October 24, 2014

Subject: Response Letter
Giverny PUD Subdivision
9180 South Wasatch Boulevard
Cottonwood Heights City, Utah
SBI Project No: 2-14-501

1.0 ADDITIONAL INVESTIGATION

ANNOTATED LIDAR IMAGERY

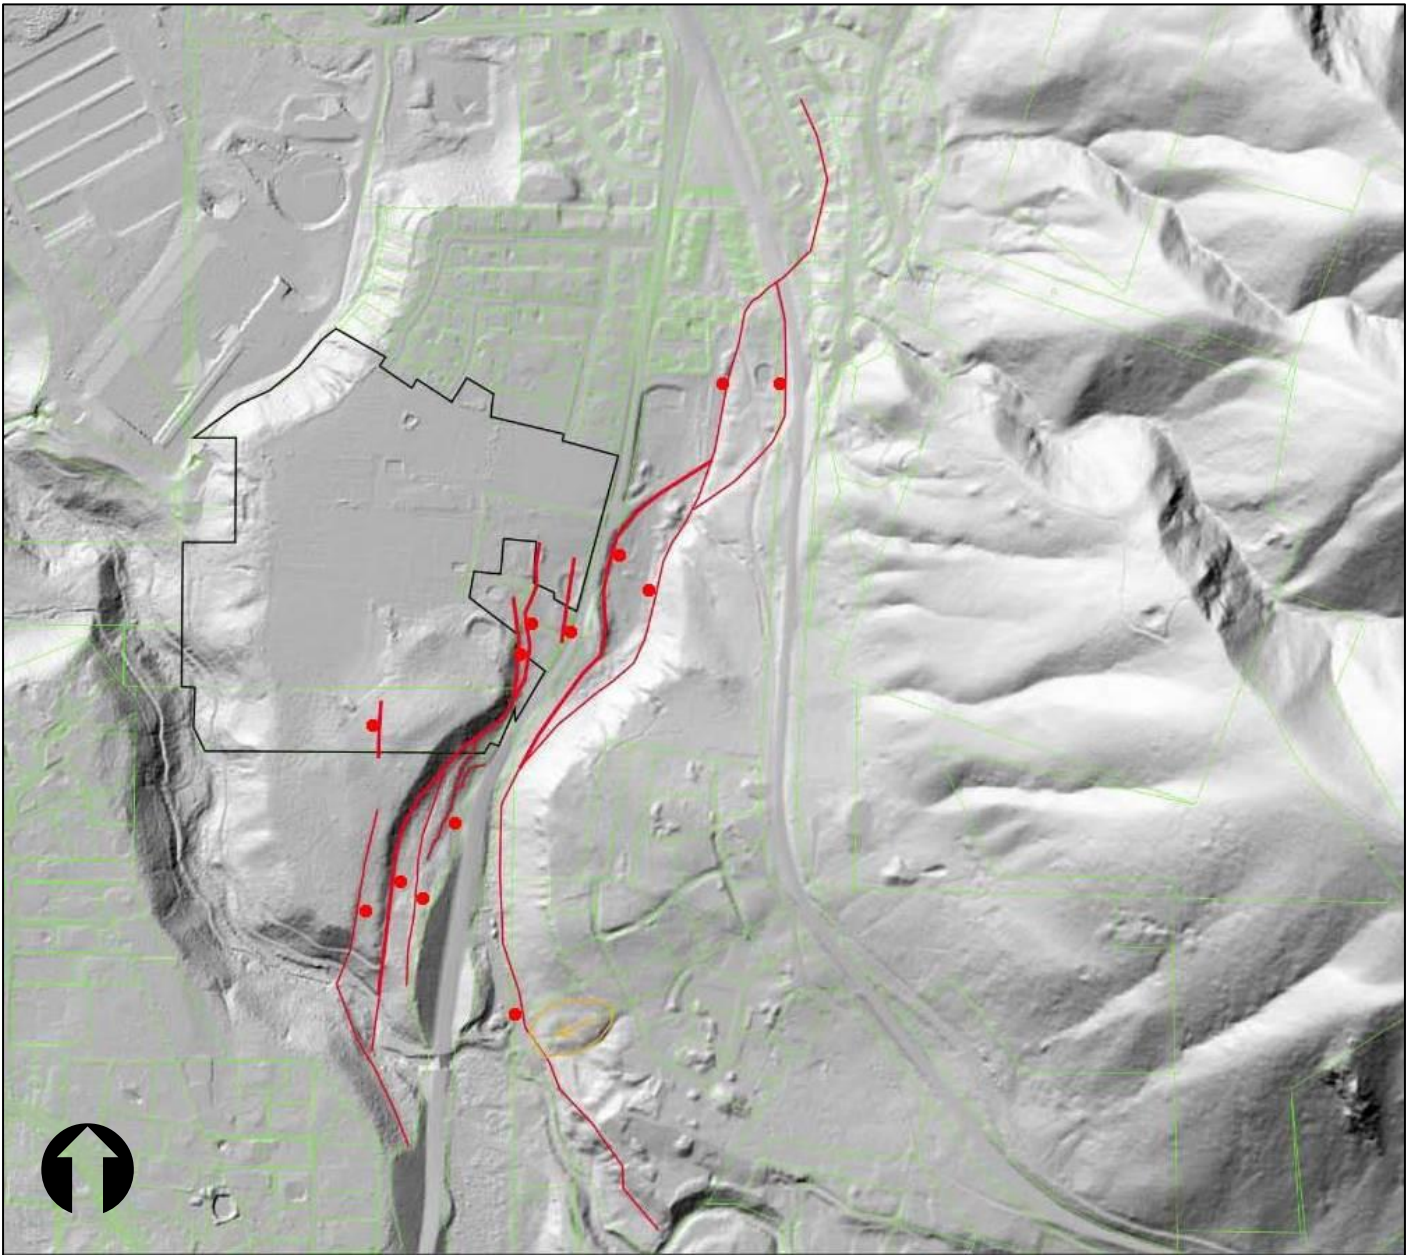
SBI reviewed LiDAR imagery (AGRC, 2006; 2013) of the property and surrounding area (Figure 1A and 1B) that were not available when the 2005 SBI investigation was performed (SBI, 2005). Aerial photographs that were not readily available in 2005 and higher resolution of photographs available in 2005 were also reviewed (see references cited).

A new fault was identified on the LiDAR and aerial imagery, F-2b, which splays from F-2a (Figure 2). F-2b crosses a relatively small part of the site, immediately adjacent to the south side of Wasatch Boulevard (designated for open space). Based on analysis of LiDAR imagery (Figure 1A and 1B) and aerial photographs, F-2b, terminates within the Big Rock Estates property. Therefore, it is judged that F-2b does not impact the proposed development.

Based on analysis of LiDAR imagery and aerial photographs, the length of F-3 has been revised. It is our opinion that F-3 does not extend southward and connect to the single scarp-forming antithetic fault in the southeast corner of the parcel as documented in SBI, 2005. The southern end of F-3 likely terminates within the Big Rock Estates property or F-3 may extend to the southeast, across Wasatch Boulevard, connecting to a fault on the east side of Wasatch Boulevard.

Based on analysis of LiDAR imagery and aerial photographs, the location of F-4 has been revised. It is our opinion that F-4 does not cross Wasatch Boulevard to connect with the scarp-forming antithetic fault in the southeast corner of the parcel as documented in SBI, 2005; F-4 is located entirely on the east side of Wasatch Boulevard as shown on Figures 1 and 2.

REVISED FAULT MAP

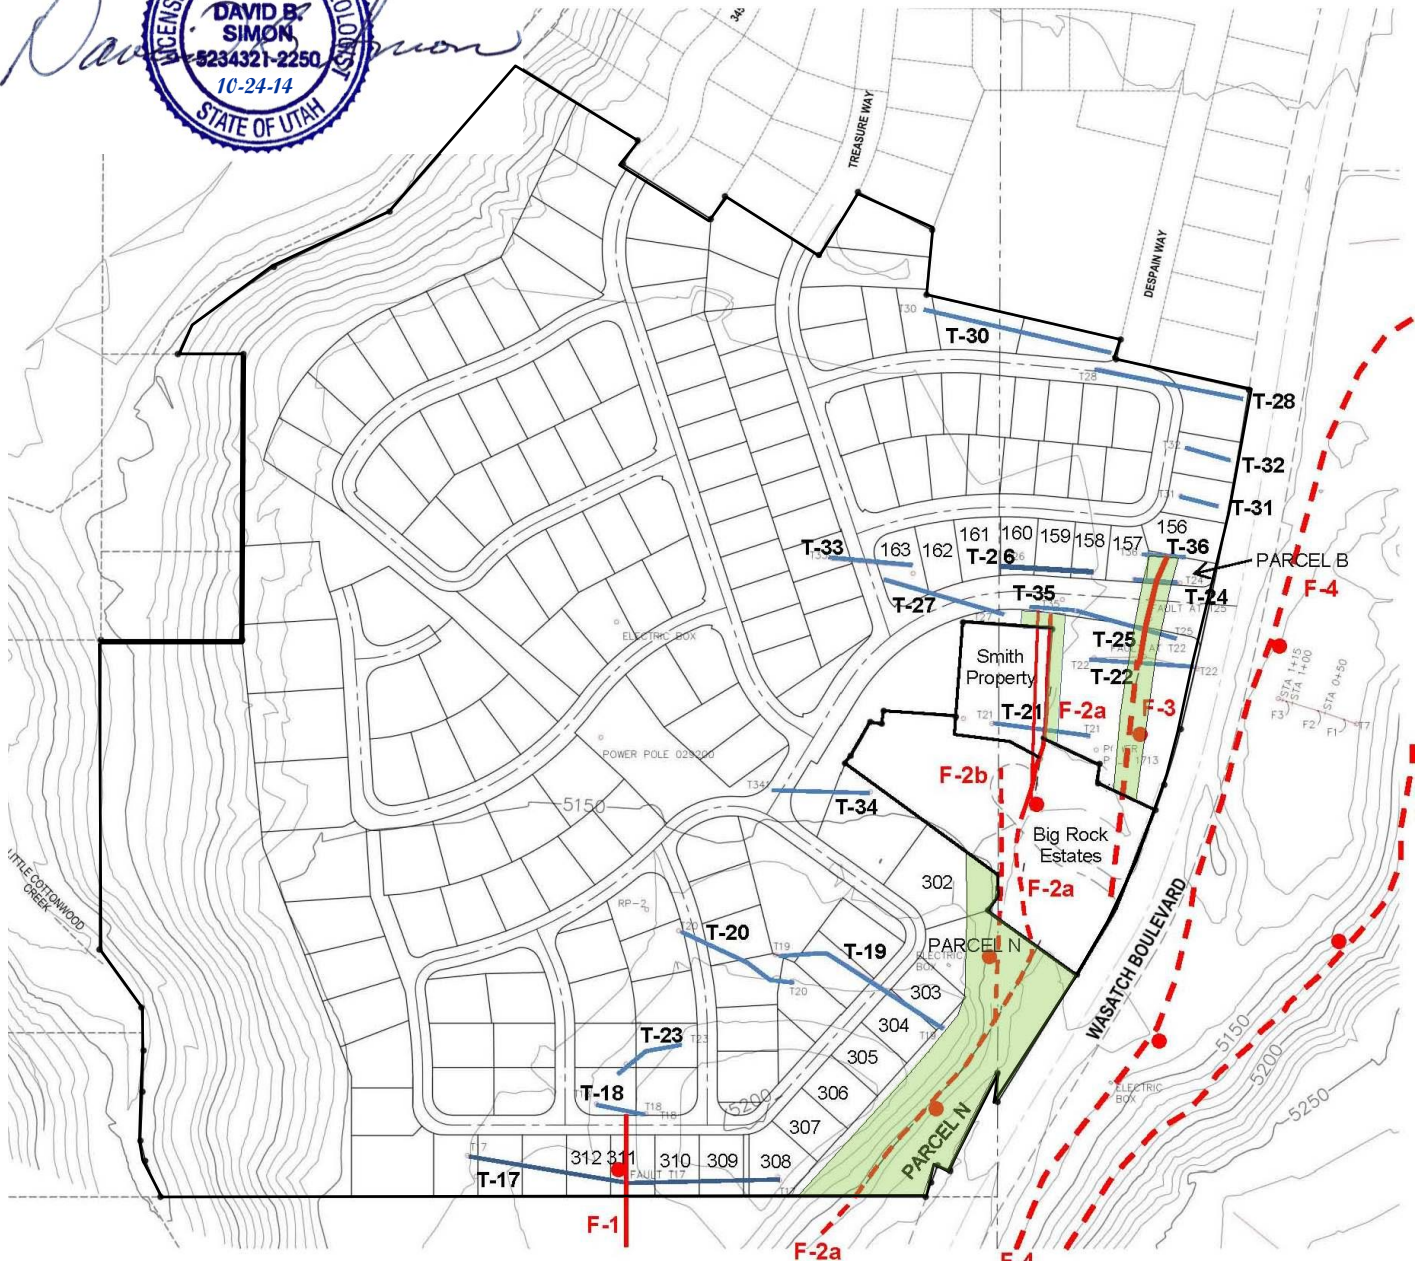
The fault shown on Drawing 1 of the 2005 SBI report (SBI, 2005), is the eastern-most fault documented in T-21. CH City requested that the location and setback ramifications of the western-most fault also be considered. In that regard, the building/fault setback area on the west side of the fault shown on Figure 2 has been increased by 43 feet (28 feet for the width of the zone and an additional 15 feet for the recommended building setback).

The east-most corner of Lot 302 is at the top of the fault scarp (i.e., slope) of the antithetic fault near the southeast corner of the parcel (Figure 2). The southeast boundary of Lots 303 through 308 are located from 5 feet (Lot 308) to 30 feet (Lot 303) west of the top of the fault scarp of the antithetic fault near the southeast corner of the

Due to the steepness of the scarp/slope (which exceeds 45° in places) and abundant boulders in the underlying earth materials, trenching of the scarp was not logistically feasible. Because of the difficulty of physically locating fault F-2 in Parcel N's rugged terrain, in the SBI, 2005, investigation, the fault was located at an elevation corresponding to about one-third of the slope height. Faults in fault scarps are generally located within the lower third of the slope/scarp (McCalpin, 1987; 2002; DuRoss, 2008).

A 50-foot setback was recommended for fault (F-2a) south of Big Rock Estates. Fifty feet was considered conservative, given the likely location of the fault and the absence of faulting documented in Trenches T-17 and T-19 (SBI, 2005). The east end of T-17 and T-19 are about 25 and 15 feet, respectively, from the top of fault scarp/slope.

The western-most fault (fault F3 on Drawing 23 in SBI, 2005) is a down to the east antithetic fault with 0.6 feet of displacement. The eastern-most fault (fault F4 on Drawing 23 in SBI, 2005) is a down to the east antithetic fault with 1.8 feet of displacement. Projection of the eastern- and western-most faults to the north would intersect trench T-35 (Figure 2), at about stations 0+25 and station 0+48, respectively.

Stratigraphically continuous late Pleistocene-age Bonneville lake cycle sediments were documented throughout T-35 (Figure 3). The stratigraphic continuous nature of the Bonneville lake cycle sediments in T-35 constitutes reasonable geologic evidence for the absence of Holocene-age faulting. Therefore, it is judged that no Holocene-age faults are present in T-35 and the faults documented in T-21 terminate somewhere north of T-21 and south of T-35. The area between T-21 and T-35 will not be developed.

The rear yard setback for proposed residential structures on Lots 303 to 308 is fifteen feet. Should a fault should be located immediately east of the east end of T-19, there would be at least 15 feet between the hypothetical fault and the building envelope. It is our recollection that CH City agreed in the conference call that 15 feet between a hypothetical fault and the building envelope for Lots 303 to 308 would be sufficient and further investigation in this area will not be required.

LOG OF TRENCHES T-35 and T-36

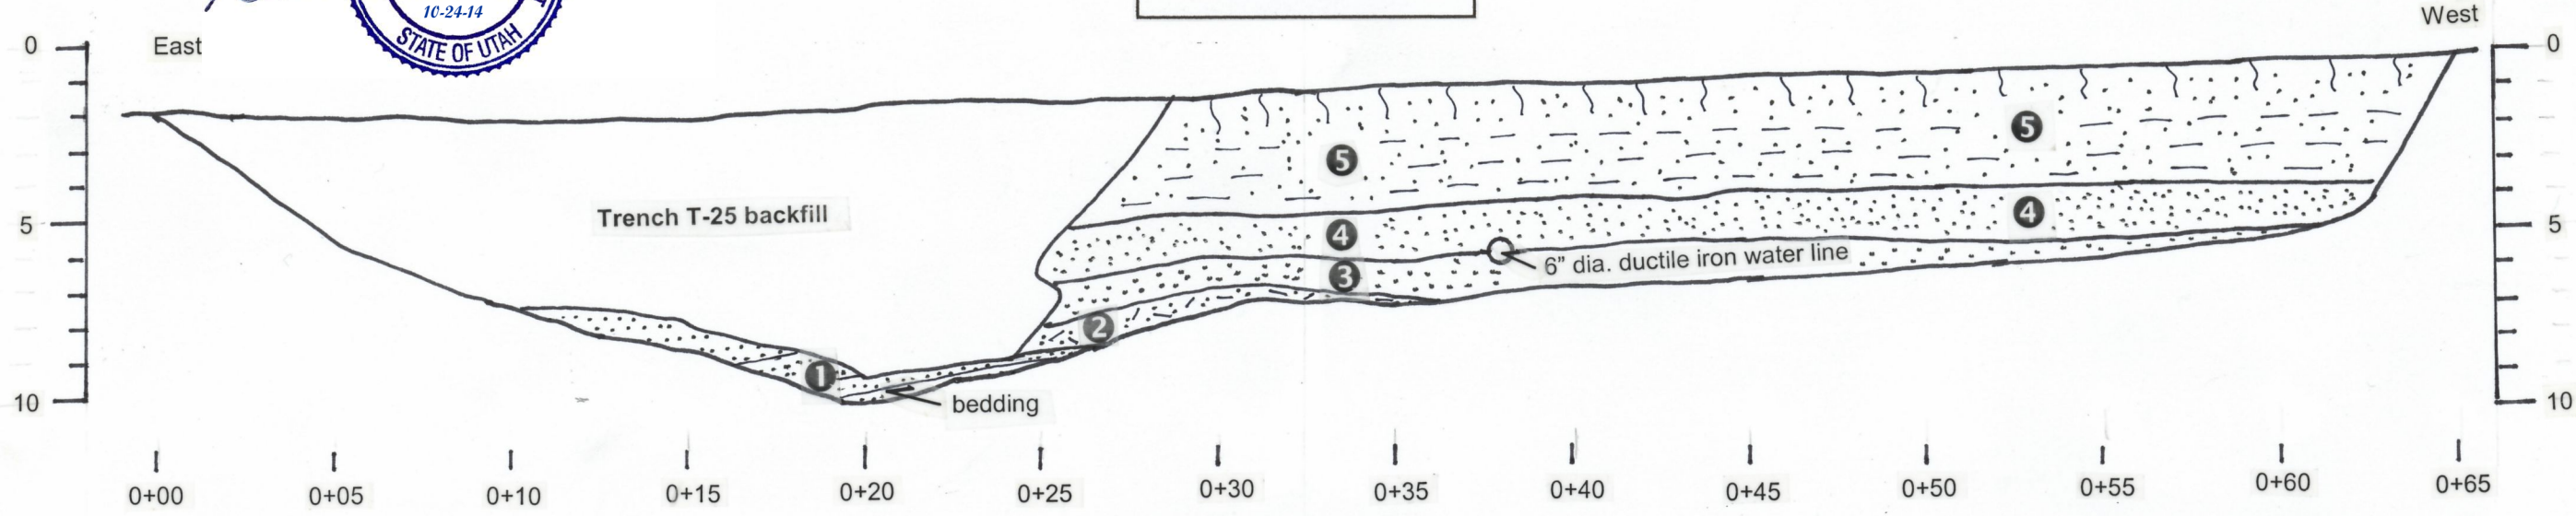
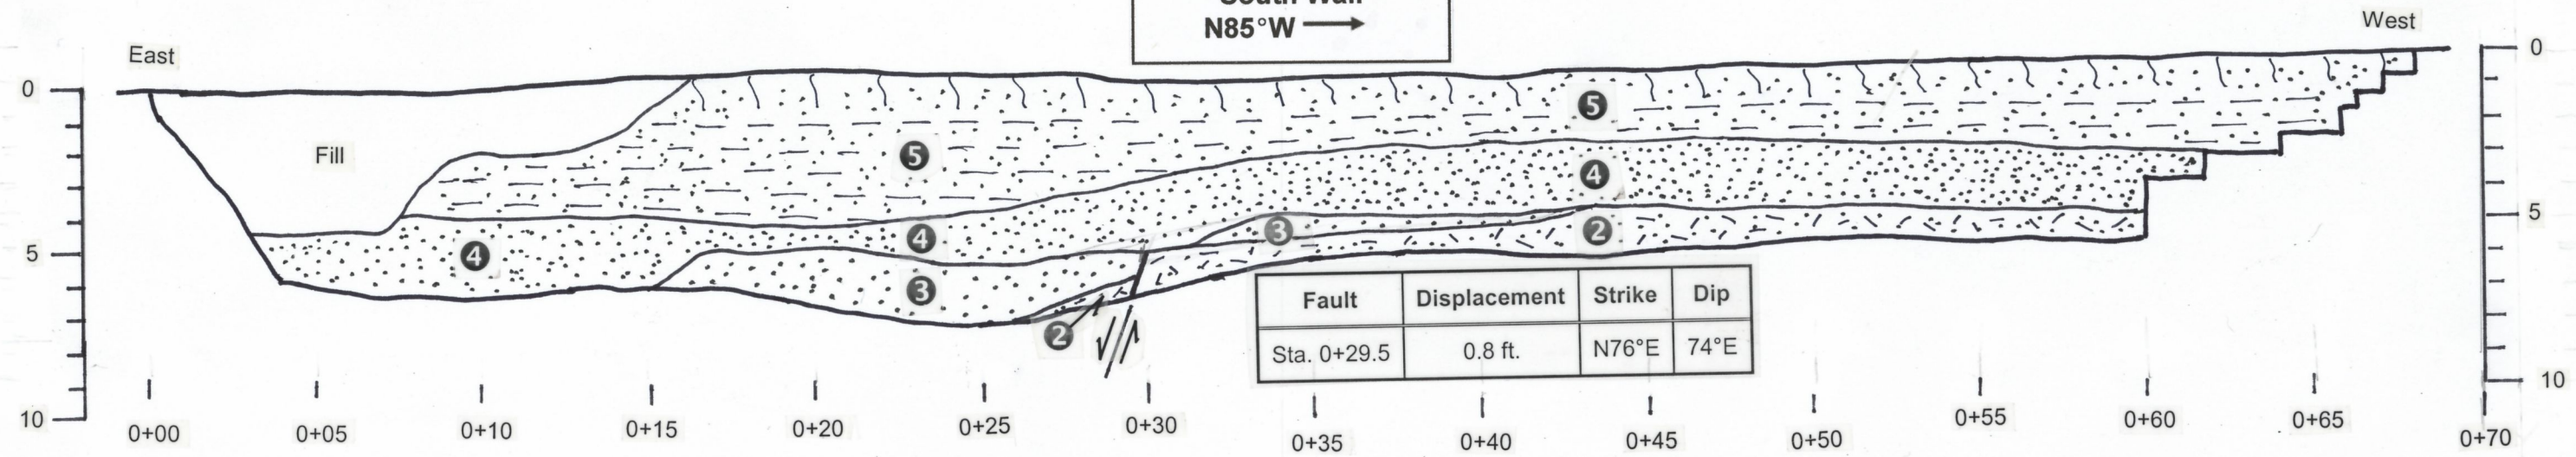
CH City stated in their review letters (GeoStrata, 2014a; 2014b): "Since SBI considers F-3 to be active and also reports observing F-3 in Trenches T-31 and T-32, the projection of F-3 should be shown trending through T-32 and to a point that SBI has demonstrated is the northern terminus of F-3. The entire length of F-3 should be considered active; not just the portion of F-3 "exhibiting evidence of greater than four inches of displacement along one or more of its traces during Holocene time ... SBI also reports F-3 to extend north of T-32 as shown on Drawing 37."

Displacement along F-2a increases southward from T-35, where the fault was not documented, to about 1.8 ft. in T-21. In T-35, no faults were documented within a 6-foot thick sequence of stratigraphically continuous Bonneville lake cycle sediments (\geq 14,000 years old) (Figure 3).

Trench T-36 (Figure 3), was excavated on August 28, 2014, to refine the northern terminus of fault F-3. In T-36, an antithetic fault was identified at Station 0+29.5. The fault trended 163°, was inclined (dip) about 76° to the east, and about 8 inches of displacement was documented. Of importance is the fault was demonstrably overlain by

Analysis of LiDAR imagery, aerial photographs, and topographic data, supports the absence of surface faulting north of T-36. Based on these data, including exposures in T-36, the north terminus of F-3 is judged to be at T-36.
